## Davis Besse re-licensing community hearing

**Figure 1 Overview of Presentation on 12/18/2010**

**Figure 2 Volatility vs Maximum Output of several hypothetical combination systems of solar and wind**

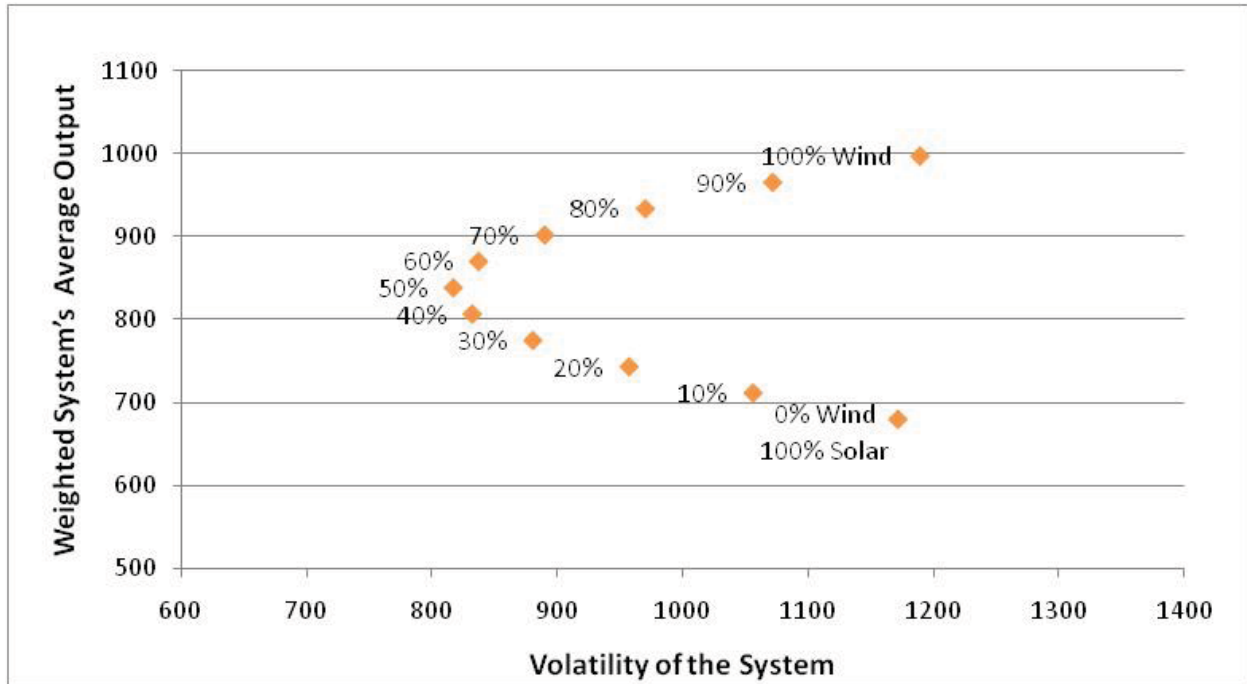
I have used two functioning systems in the area, one wind turbine owned by Bowling Green Municipalities and one solar array on a home located about 20 miles north of the turbine in Toledo. With detailed statistical modeling, the above graph shows the volatility or intermittency of 10 hypothetical systems versus their output. Each hypothetical system is a different weighted combination of solar and wind, from 0 - 100% wind. As you can see, the system with the least volatility (most stable) is an even combination of 50% solar and 50% wind.

Figure 3 Output of hypothetical system vs demand curve from central Texas, similar to that of Toledo.

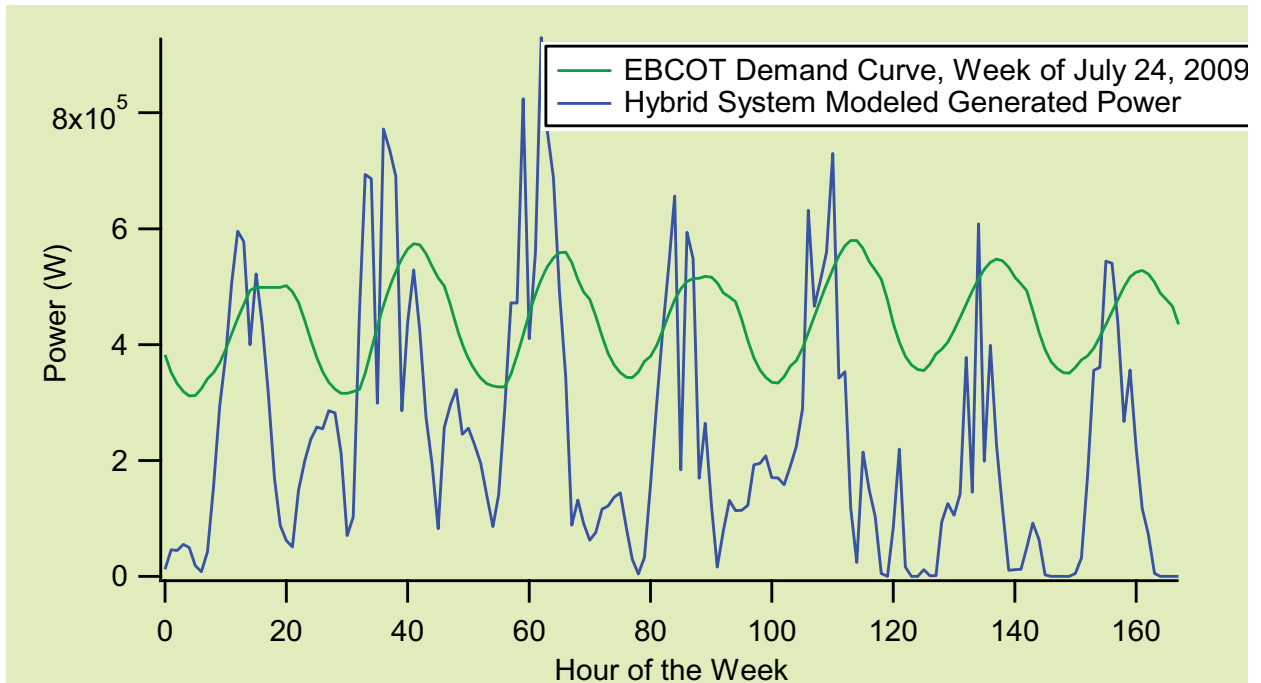
A single solar array follows patterns in its power production: only produces in the day, not at night and also the production is higher in the summer on average than in the winter. A single wind turbine also follows patterns: not as much predictability from day to day, however they produce more on average in the winter than they do in the summer months. By combining these two sources at the optimal ratio for the area, a much more stable and predictable output can be obtained. The slide below shows the hypothetical combination system against a large city demand curve like Toledo. We can also look at the system over an entire year and see that the standard deviation (measure of volatility) is consistently lower than either by itself.
